AGENDA

PLANNING AND ZONING COMMISSION WORK SESSION City Hall, 385 South Goliad, Rockwall, Texas Council Chambers January 29, 2019 6:00 P.M.

SHEET 1 of 1

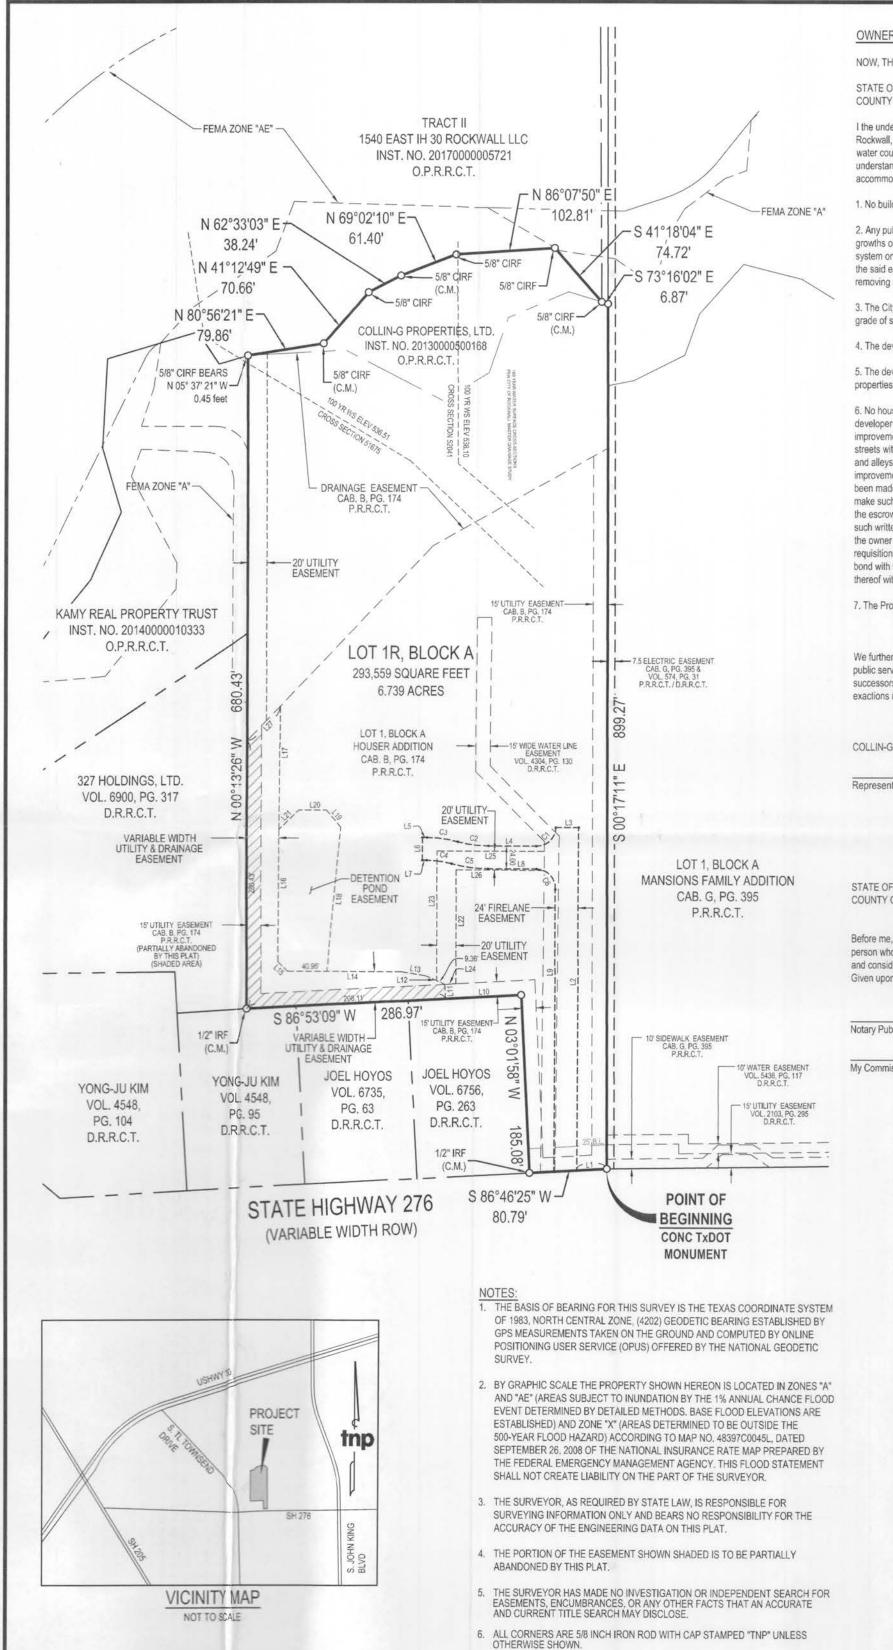
- 1. The final plat shall conform to all standards and requirements of the Unified Development Code(UDC), the staff comments provided by the Planning Engineering, Building Inspection, and Fire Departments as indicated on the Project Plan Review document
- 2. Provide a label indicating "Case No. P2019-002" on the lower right corner on all pages of the revised final plat submittal
- 3. Include a label on platted lot that identifies the name of the subdivision[i.e. Houser Addition] and to be located above 'Lot 2, Block A'.
- 4. Correct lot number on plat and title block to indicate "Lot 2" [do not use Lot 1R].
- 5. Correct Title Block heading as follows:

- 6. Relabel firelane as "24-ft Firelane, Public Access, Drainage and Utility Easements" as appropriate.
- 7. Change all 2018 year dates to '2019'.
